# A Review of the Three Mile Island-1 Probabilistic Risk Assessment

Prepared by H. J. Reilly, D. L. Schurman, H. J. Welland, R. C. Bertucio,  
S. A. Eide, P. R. Davis, S. E. Mays, A. J. Buslik, N. C. Chokshi

Idaho National Engineering Laboratory  
EG&G Idaho, Inc.

Prepared for  
U.S. Nuclear Regulatory Commission

Figure 1. Nonhurricane and hurricane frequency curves.

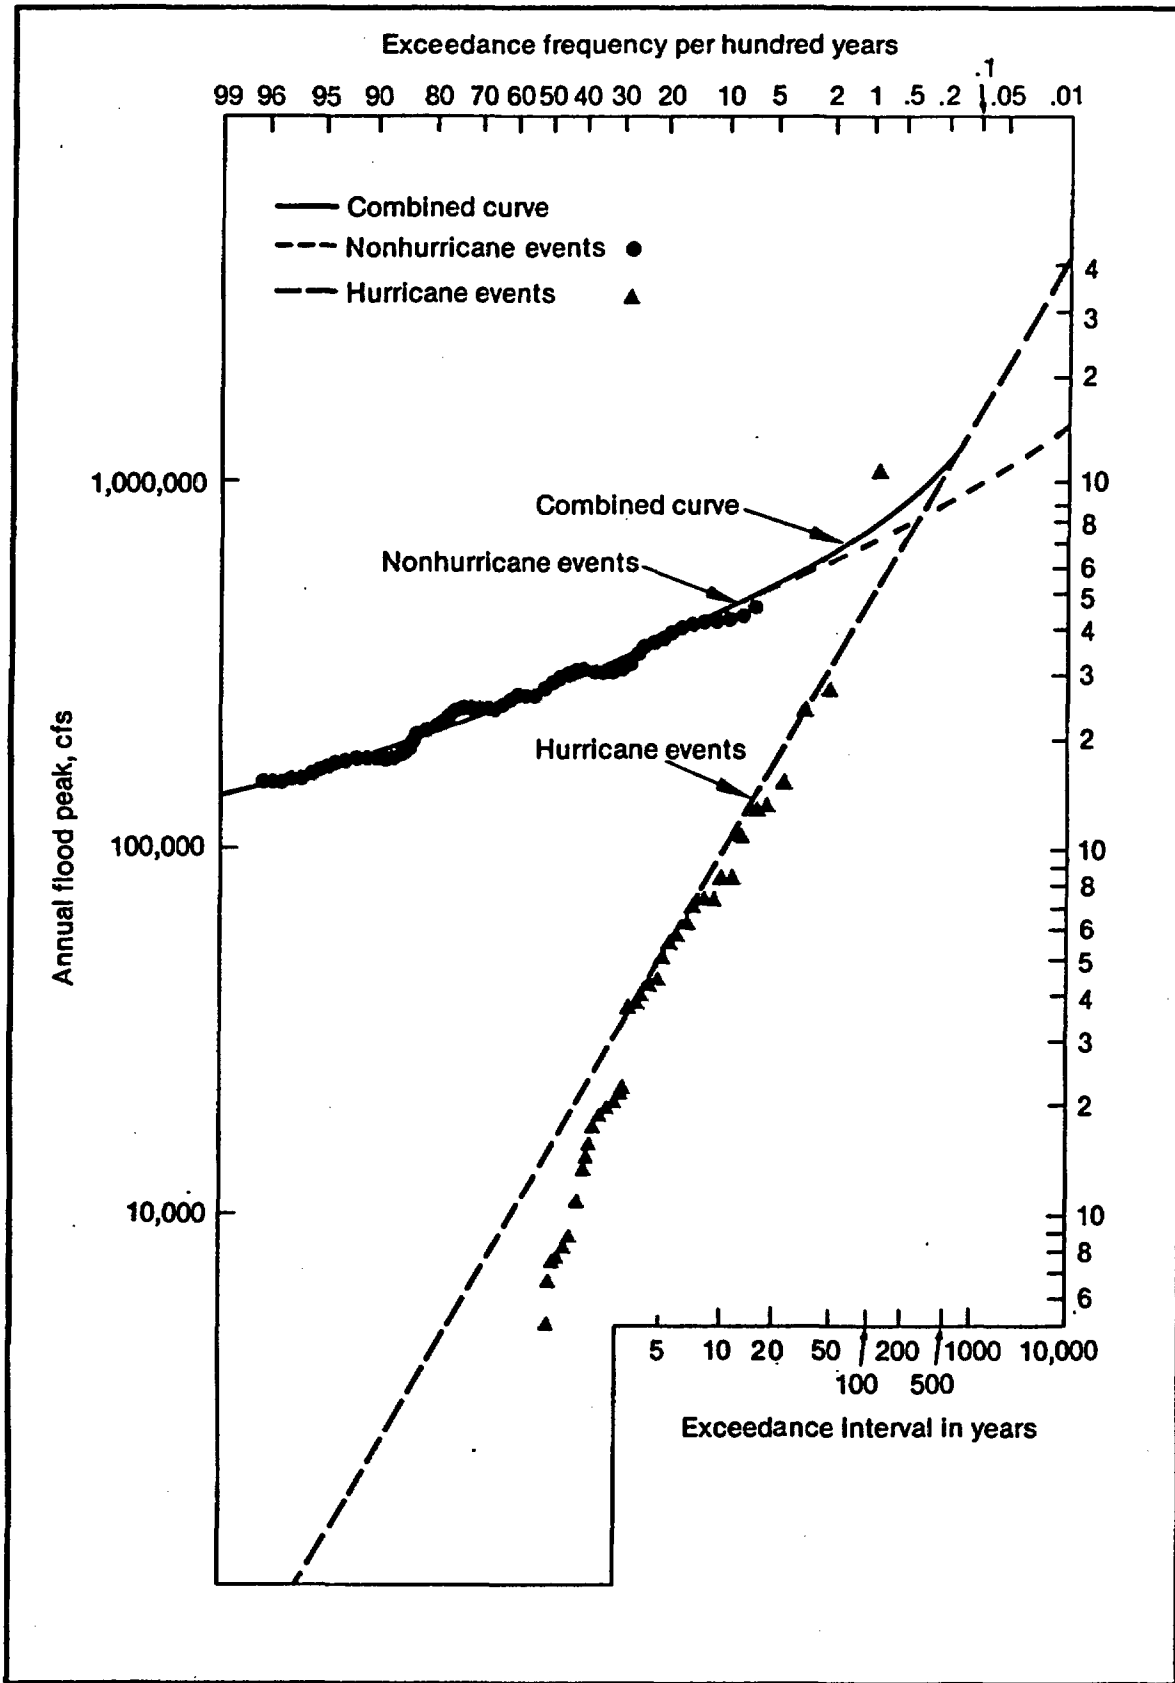
A Corps of Engineers (COE) report prepared in 1975 estimates the frequency of a flood greater than 1,750,000 cfs at Harrisburg to be approximately  $7E-04/yr$ , based on a figure which is reproduced here as Figure 1.<sup>41</sup> This frequency estimate is based on plotting hurricane and non-hurricane floods separately. The curve drawn through the hurricane flood data has a much steeper slope than that through the non-hurricane flood data. Note that the curve passes below the 1972 flood data point; this feature of the curve is consistent with the methodology recommended for Federal agencies.<sup>42</sup>

**Figure 2.** Estimated frequency curve for Susquehanna River at Harrisburg, PA, in accordance with Bulletin 17B.

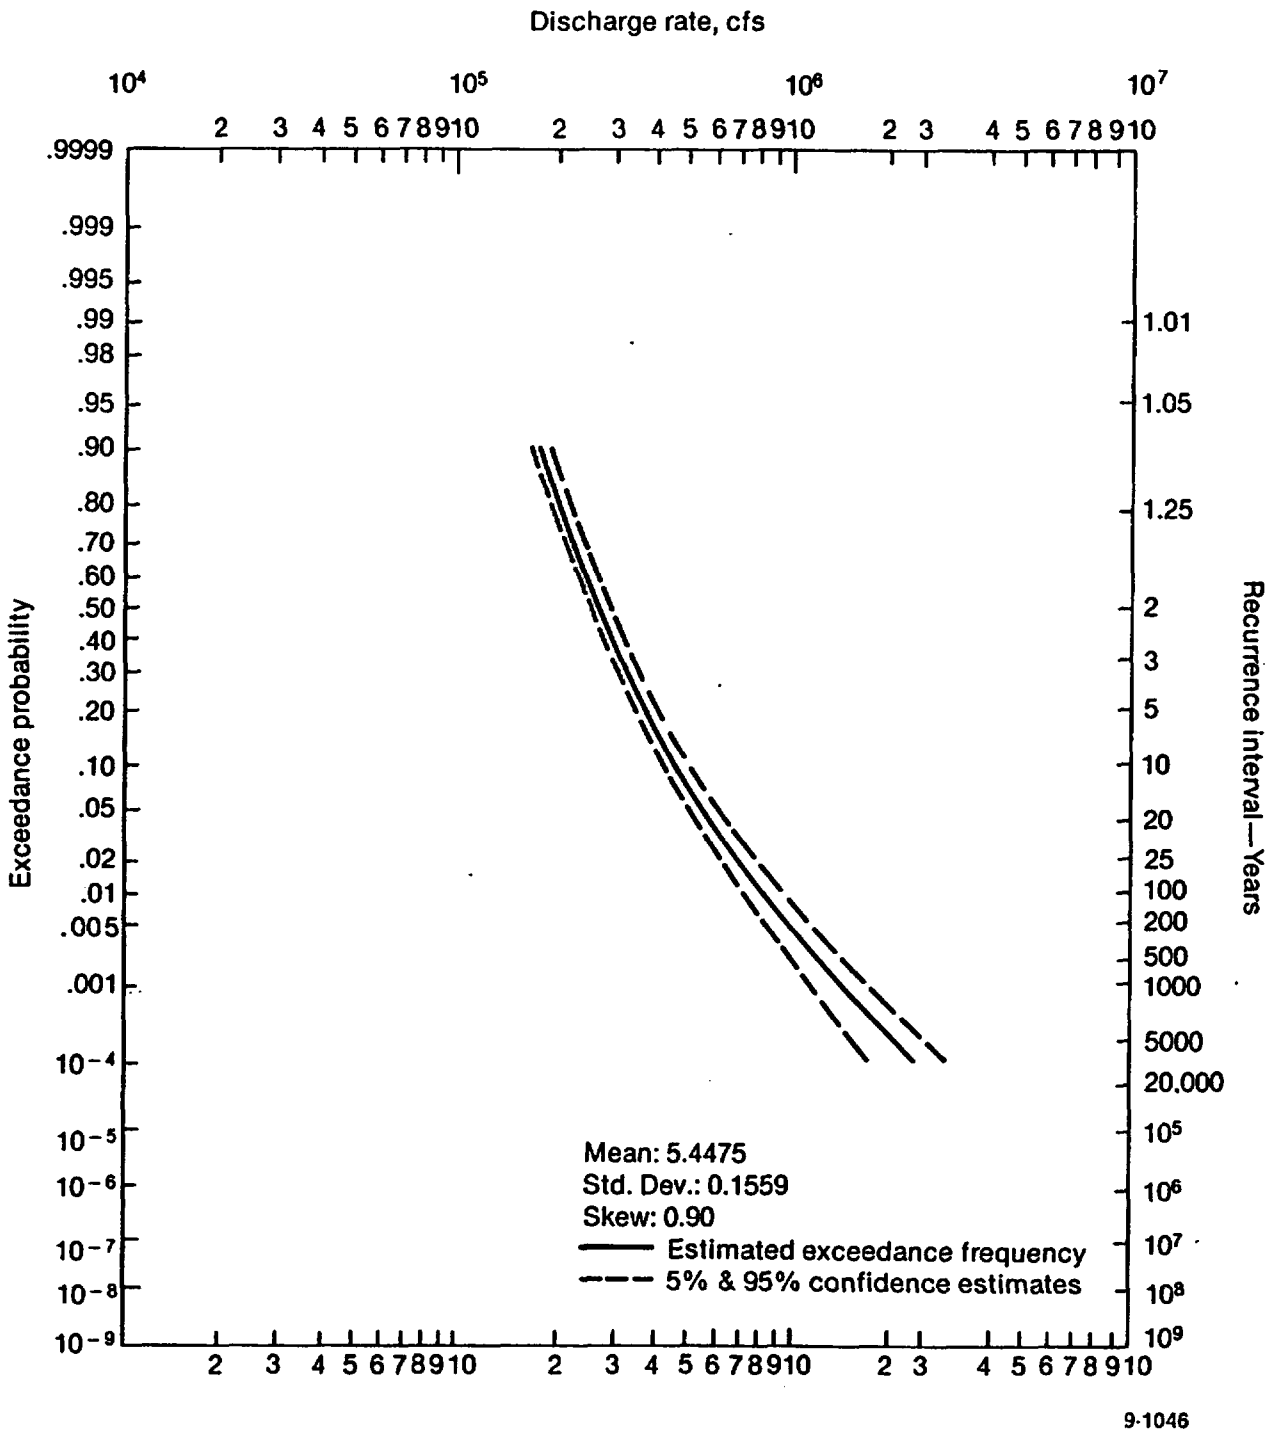
In a personal communication between COE and NRC,<sup>a</sup> the COE stated that, using all data up to 1983, they estimated the parameters of such an equation to be  $\log$  mean = 5.4475, standard deviation = 0.1559, skew coefficient = 0.90, where units of flow are cfs. This equation predicts the exceedance frequency of the PMF to be about  $3.2E-04/yr$ , with an uncertainty factor of 5, see Figure 2 (the expected value

It is also appropriate to address the frequencies of core damage due to floods 305–310 ft. These frequencies will be greater than shown in the PRA if the COE equation or the curve of Figure 2 is used—i.e., about  $8E-4/yr$ . The PRA takes substantial credit for protective actions (early warning, shutdown, installation of cover plates) in the event of a flood 305–310 ft. During the plant visit, the personnel at TMI-1 indicated they did not practise installing the cover plates. The PRA assumed that a hurricane is unlikely to produce the PMF at the site, and that the emergency closure actions (top event SL) could be considered routine (sufficient time) rather than dynamic. However, it appears to us that the PMF is more likely to be produced by a hurricane. It seems the approach of the hurricane-induced flood, with the emergency closure taking place, would be accompanied by loss of offsite power along with heavy rain and high winds on site. The personnel would have one chance to make proper installation because after the arrival of high water, the island would be flooded, leaving little if any chance to correct any deficiencies. The PRA estimates the human error rates with a recovery factor of 0.19 to account for potential recovery in the event any steps in the emergency closure (top event SL) have failed. Our review indicates that the human response analysis results would not be changed for the decrease in warning time that would be involved in a hurricane-caused PMF. The human response analysis did not consider the likelihood of a cover plate or air-inflatable seal being defective and nonrepairable within the available time. The PRA may be optimistic in this regard. However, on a best estimate basis, the floods 305–310 ft are not as important as those above 310 ft.

Figure B-1. Annual frequencies of loss of offsite power (LOP) exceeding a time T. (Review Estimates)

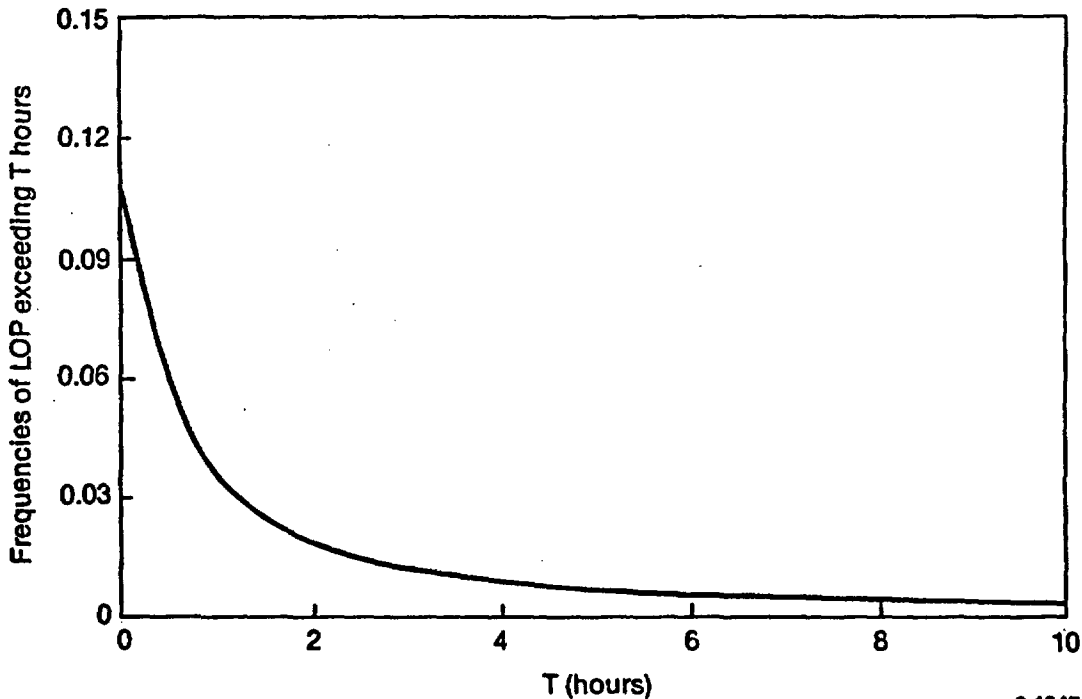
Figure B-1 gives the frequency of losses of offsite power exceeding a duration  $t$ , as calculated from the above expressions.

Figure C-1. TMI plant fragility curve.

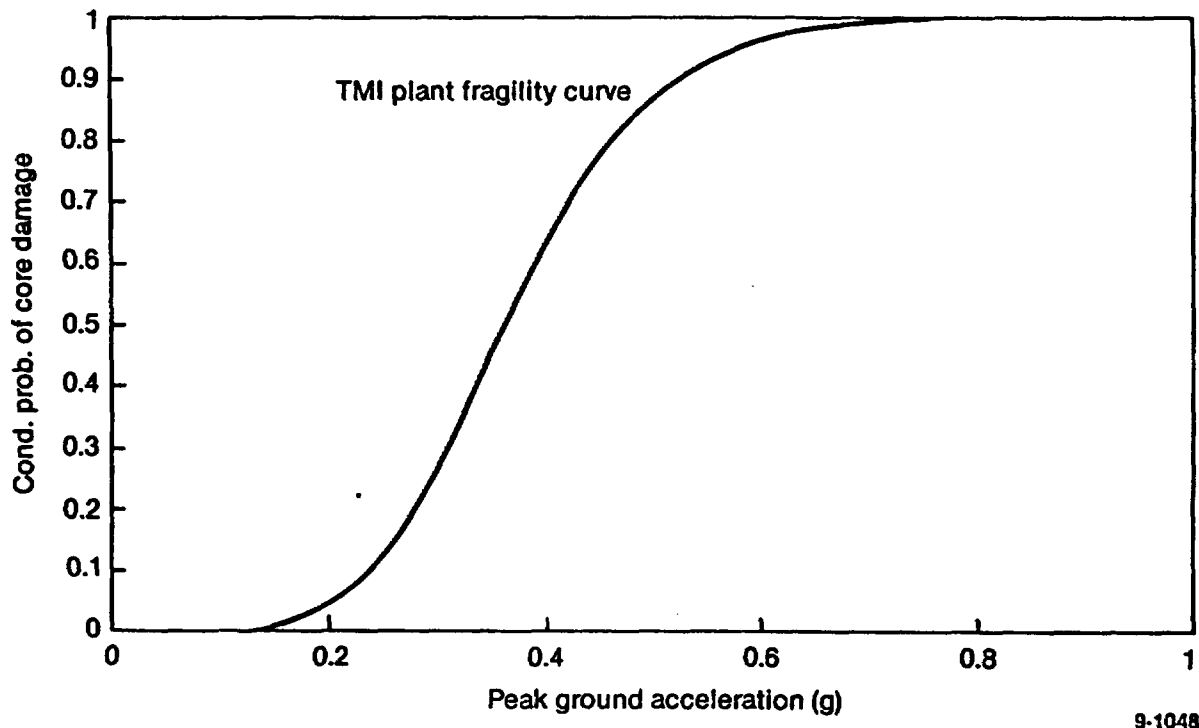
The quantity  $\text{pr}\{S1 + S2 + S3 \mid a\}$  is the conditional probability of core damage given a pga of a. When considered as a function of a, it is sometimes called the plant fragility curve. The mean plant fragility curve is displayed in Figure C-1. One sees that there is about a 50% chance of core damage, given a pga of 0.36g. Since the Safe Shutdown Earthquake (SSE) corresponds to 0.12g for the pga, there is a 50% chance of core damage at about 3 times the SSE pga. Typically the 50% point on the plant fragility curve is between twice the SSE and four times the SSE, so the results for TMI are not unusual.
